Powers Engineering

July 22, 2010

Subject: Proposed Regulation for California Renewable Energy Standard

Figure 1. 2010 cost of distributed utility-scale fixed PV identified by DOE

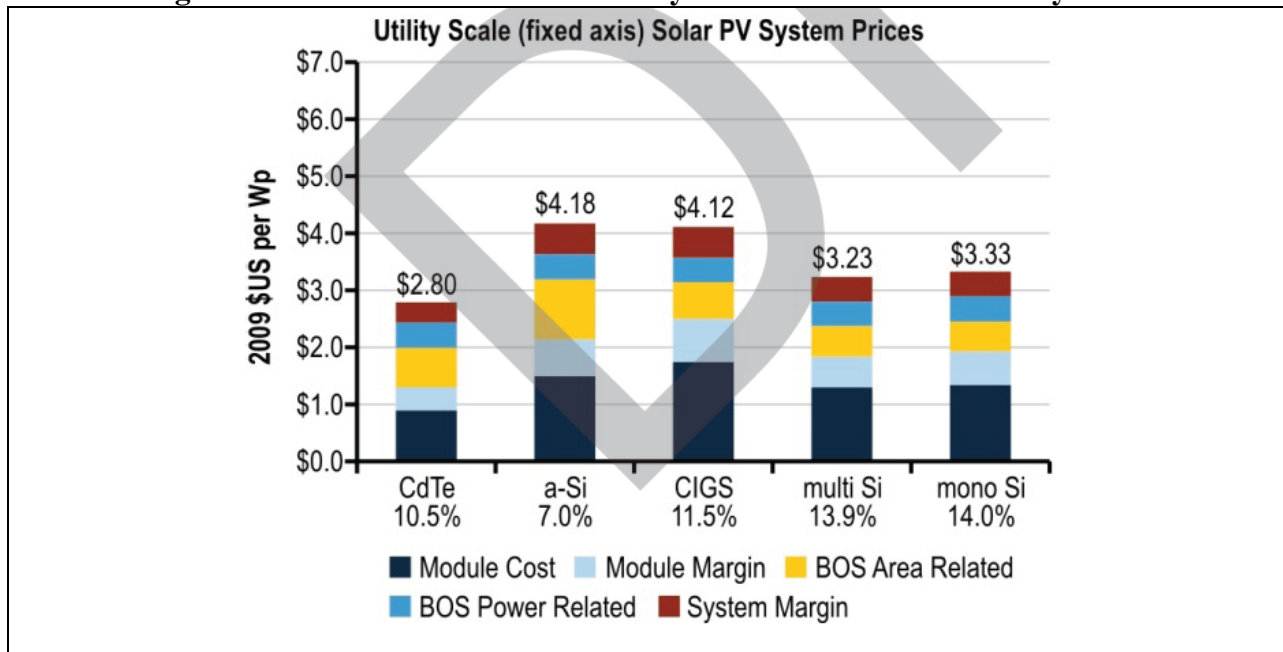
The DOE Solar Vision Study also estimates a much lower cost for solar PV than the cost used by CARB. DOE estimates utility-scale distributed thin-film PV at \$2.80/Wdc.^{14,15} See Figure 1. RETI identifies the range of dc-to-ac conversion factors of 0.77 to 0.85.¹⁶ Assuming an average dc-to-ac conversion factor of 0.80, \$2.80/Wdc converts to \$3.36/Wac. This is substantially lower than the \$4/Wac used by CARB as the basis for a solar PV LCOE of \$187/MWh. It is also substantially lower than the \$3.70/Wac that E3 and Black & Veatch use as a basis for a solar PV LCOE of \$168/MWh.¹⁷

In sum, CARB should rely on the DOE or RETI data for current commercial rooftop and distributed utility scale PV costs.

Figure 2. 2010 cost of commercial rooftop PV identified by DOE

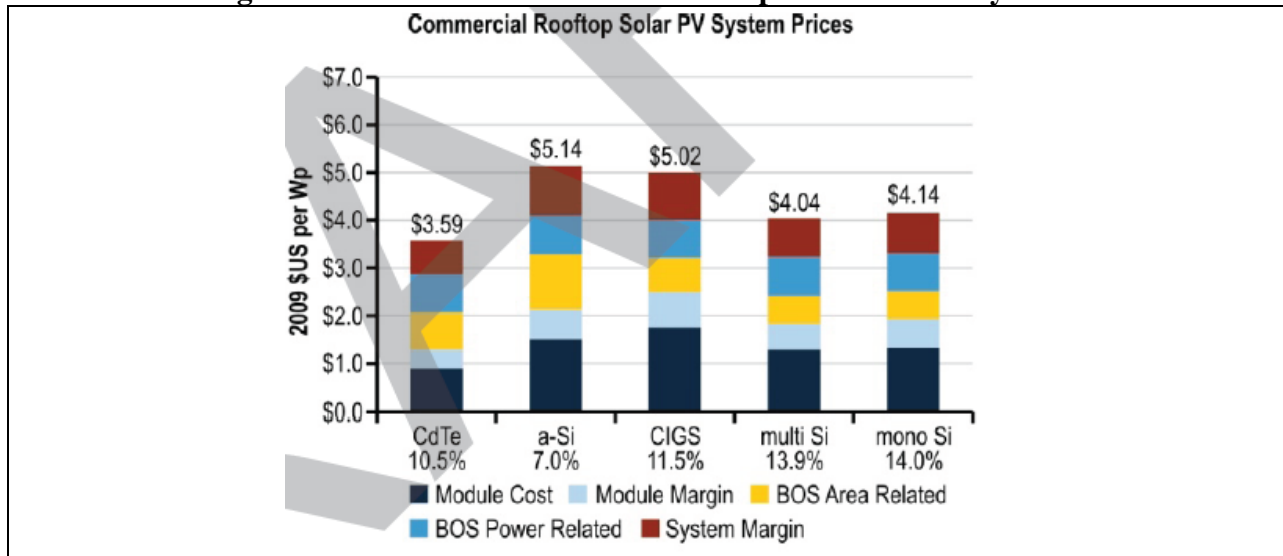
DOE’s projection of current commercial rooftop PV capital cost is provided in Figure 2.¹⁸ As shown in Figure 2, the current capital cost of commercial rooftop polycrystalline silicon PV, identified as “multi Si” and “mono Si”, is approximately \$4/Wdc. Using a dc-to-ac conversion factor of 0.80, the capital cost of commercial rooftop polycrystalline silicon PV is approximately $\$4/\text{Wdc} \div 0.80 = \$5/\text{Wac}$.

The polycrystalline silicon commercial rooftop PV capital cost of \$5/Wac is incrementally less than the \$5.35 to \$5.55/Wac capital cost of dry-cooled solar thermal identified by RETI. The most common form of thin-film PV, CdTe (cadmium-telluride), is lower in cost than polycrystalline silicon PV in commercial rooftop applications at approximately \$3.60/Wdc as shown in Figure 2,. This converts to $\$3.60/\text{Wdc} \div 0.80 = \$4.50/\text{Wac}$. Thus, the DOE estimates of actual commercial rooftop PV capital costs in 2010 are lower than either CARB or RETI capital cost estimates for solar thermal. The lower cost of commercial rooftop and distributed utility-scale PV suggest that the cost of the proposed 33 percent RES, of which the solar component consists of more than 80 percent solar thermal resources, could be reduced by incorporating a higher percentage of solar PV in the renewable generation mix.

Figure 3: CEC Projects Solar and Wind to Decline from 2009 to 2028 (Real 2009 \$/Kwh)

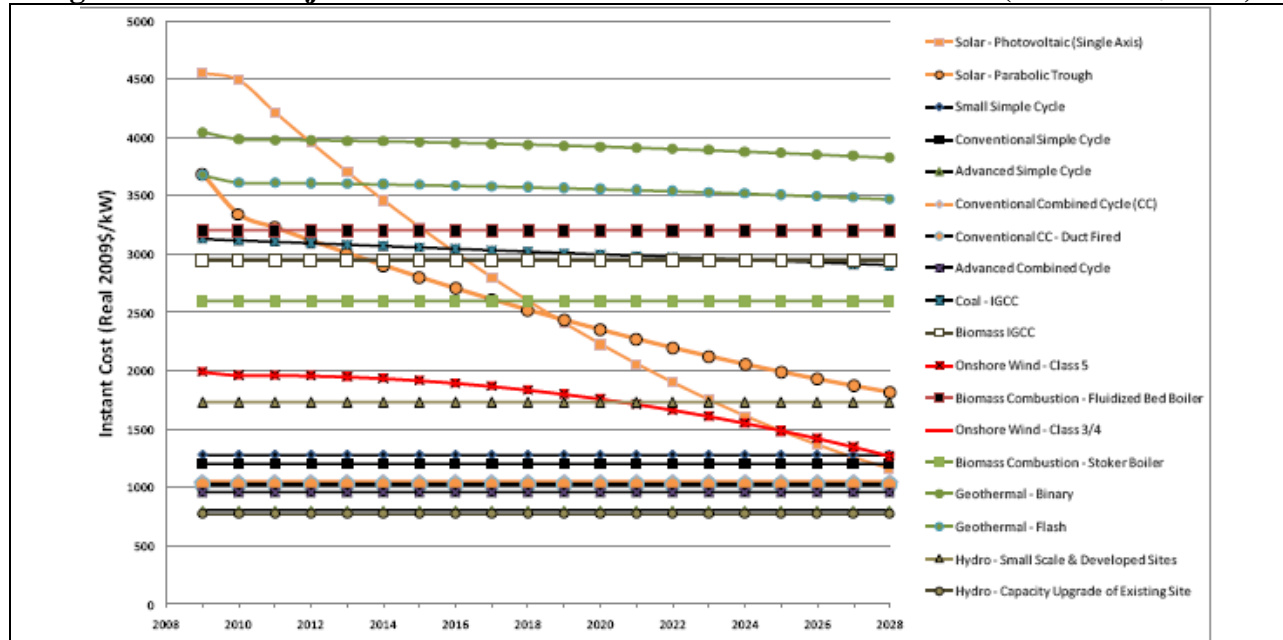
The CEC likewise predicts that solar thermal and wind will likely show significant cost declines over time. See Figure 3. The CEC forecasts a 30 percent decline in the cost of solar thermal from 2010 to 2020, and a 25 percent decline in the cost of wind power over the same period.

Figure 4. DOE Solar Vision Study projected price decline trend for solar thermal

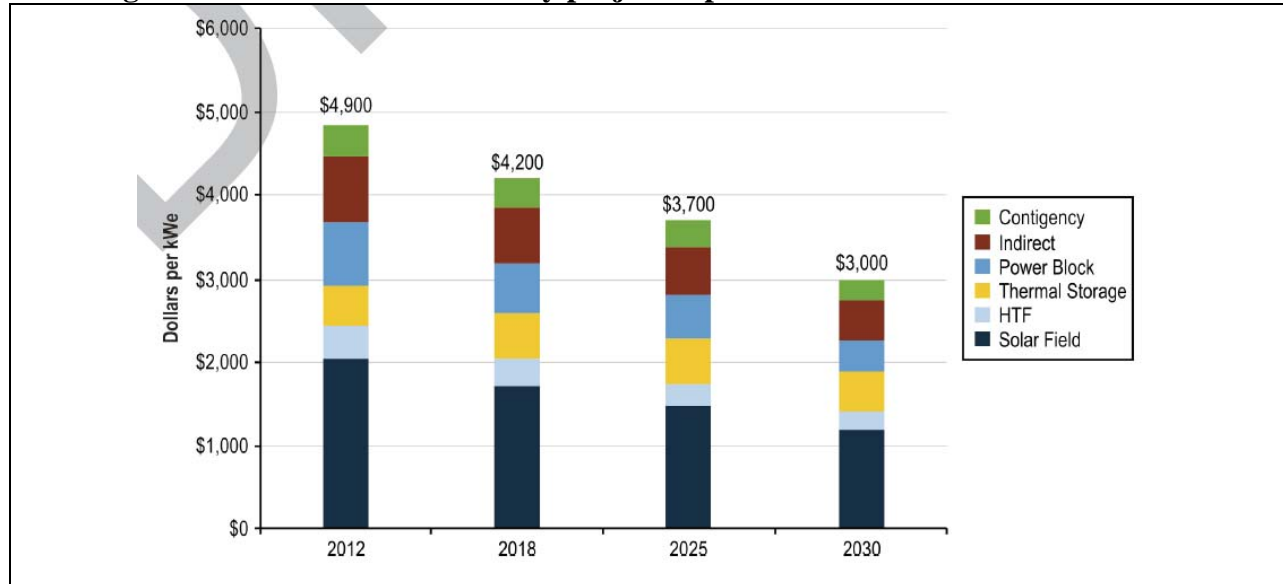
The DOE projects that solar thermal will decrease by approximately 20 percent between 2010 and 2020.²³ See Figure 4. DOE is not explicit whether the solar thermal costs shown in Figure 4 are for wet-cooled or dry-cooled solar thermal plants.

The LCOE identified by RETI for dry-cooled solar thermal in 2010 at best-in-class sites is \$195/MWh. Assuming a price decline of 25 percent between 2010 and 2020, the LCOE for dry-cooled solar thermal will be in the range of \$150/MWh in 2020.^{24,25} The Staff Report does not identify a LCOE for solar thermal. However, Appendix B does list all the cost assumptions for solar thermal.²⁶ These assumptions are identical to those used in the June 2009 report prepared for the CPUC,²⁷ which stated a LCOE range for solar thermal of \$159 to \$228/MWh, or an average of \$194/MWh.²⁸

Figure 5. 2020 New Renewable Energy Requirement Identified by RETI, February 2010⁸⁵

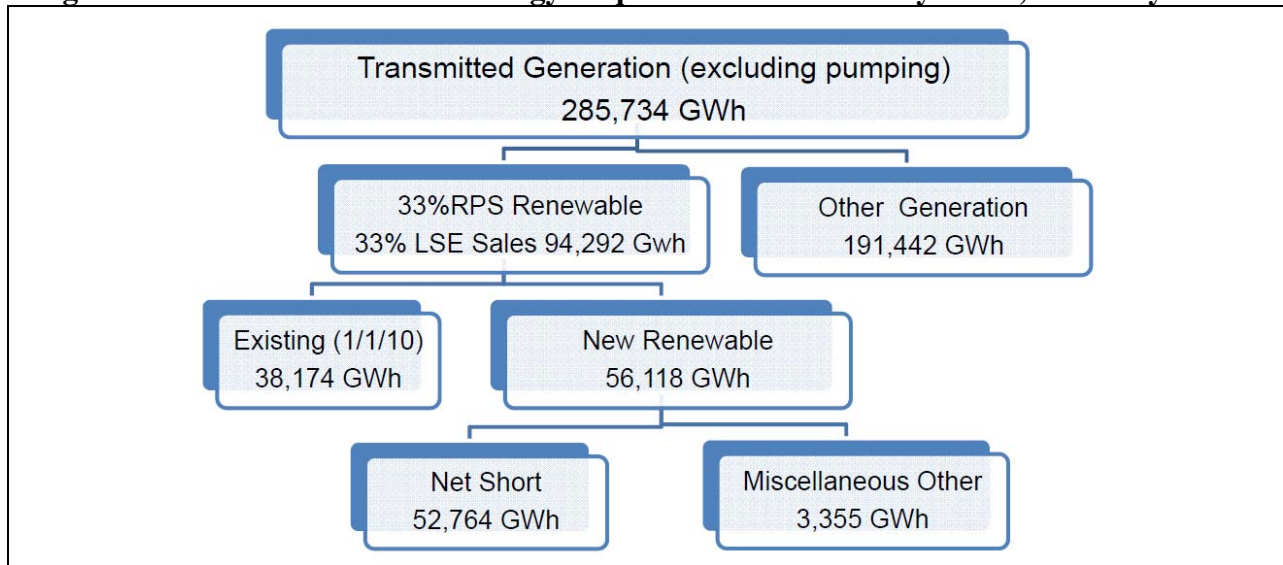
RETI identified the total new renewable energy requirement by 2020, including “net short” new renewable resources that require transmission and those that do not, as 56,118 GWh in February 2010.⁸⁰ See Figure 5.

There are two principal differences between the CARB High Load Scenario net short calculation and the RETI net short calculation: 1) CARB includes water agency pumping consumption in its projection of 301,000 GWh eligible “load serving entity” (LSE) retail sales in 2020,⁸¹ and 2) CARB assumes approximately 7,000 GWh less existing renewable energy production than RETI.

CARB’s use of 301,000 GWh eligible LSE retail sales in 2020 is incorrect. A fraction of utility supply, 13,556 GWh, is used by water agencies for pumping loads and is not subject to RPS requirements.⁸² This 13,556 GWh should have been subtracted from the 301,000 GWh total used by CARB and was not.

RETI assumes approximately 7,000 GWh more existing renewable resources will be available than CARB based on January 2010 input to RETI from the CEC.⁸³ CARB uses an estimate of 31,270 GWh existing renewable energy resources.⁸⁴ There is no discussion regarding the development of this value in Appendix B to the Staff Report, only an apparently unedited discussion of the net short calculations used in the June 2009 33percent RPS analysis E3 prepared for the CPUC. The CARB estimate of 31,270 GWh compares to the CEC’s January 2010 estimate of 38,174 GWh used by RETI. See Figure 5. CARB should rely on up-to-date inputs and adopt 56,118 GWh as the new renewable energy requirement in the proposed 33 percent RES High Load Scenario.

The proposed RES Low Load Scenario should be 43,578 GWh. CARB states that “modifications to the 2009 [Integrated Energy Policy Report] IEPR forecast that reduces the grid’s load demand in 2020 from full implementation of the Scoping Plan measures related to Energy Efficiency, CHP, and Solar DG energy” would reduce eligible LSE retail sales by 38,000 GWh.⁸⁶ This results in a net reduction in renewable energy generation of 12,540 GWh in 2020 compared to the High Load Scenario.⁸⁷ Therefore the Low Load Scenario analyzed by CARB should be 56,118 GWh - 12,540 GWh = 43,578 GWh.
